UNITED STATES PATENT AND TRADEMARK OFFICE

APPLICATION NO.	FILING DATE	FIRST NAMED INVENTOR	ATTORNEY DOCKET NO.	CONFIRMATION NO.
10/699,284	10/31/2003	Daniel C. Worledge	YOR920030410US1	2560
7590 07/12/2005			EXAMINER	
Ryan, Mason & Lewis, LLP Suite 205 1300 Post Road Fairfield, CT 06824			NGUYEN, THINH T	
			ART UNIT	PAPER NUMBER
			2818

Office Action Summary

DETAILED OFFICE ACTION

FIG. 1
10

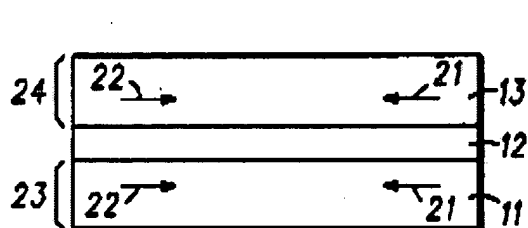
Zhu discloses (in the abstract, in fig 1) a semiconductor device comprising: at least two magnetic layers; and a spacer layer formed between the magnetic layers, the spacer layer being configured to provide ferromagnetic exchange coupling between the layers, the magnetic layers experiencing anti-ferromagnetic dipole coupling, such that a net coupling of the magnetic layers is anti-ferromagnetic in a zero applied magnetic field.

Zhu discloses (in the abstract, in fig 1) a method for coupling magnetic layers in a semiconductor device comprising at least two magnetic layers and a spacer layer therebetween, the method comprising the step of providing ferromagnetic exchange coupling of the magnetic

layers, the magnetic layers experiencing anti-ferromagnetic dipole coupling, such that a net coupling of the magnetic layers is anti-ferromagnetic in a zero applied magnetic field.

FIG. 2b

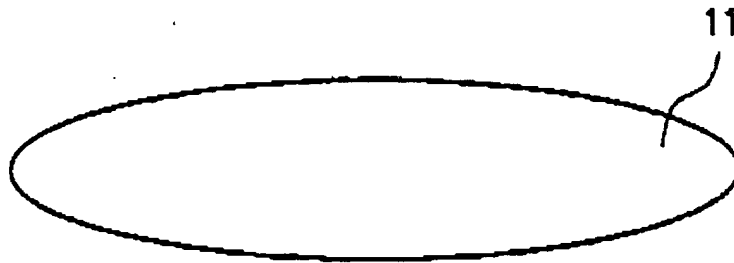
Zhu discloses all the invention except for the uses of an elliptical or circular shapes; these features, however, are considered obvious since the use of elliptical or circular shape are old and well known in the art as evidenced by the disclosure by Deak (US patent 6,728,132) fig 2b.

A person skill in the art at the time the invention was made would be able to use the disclosures by Zhu and come up with the invention of claims 6,7 without special teachings.
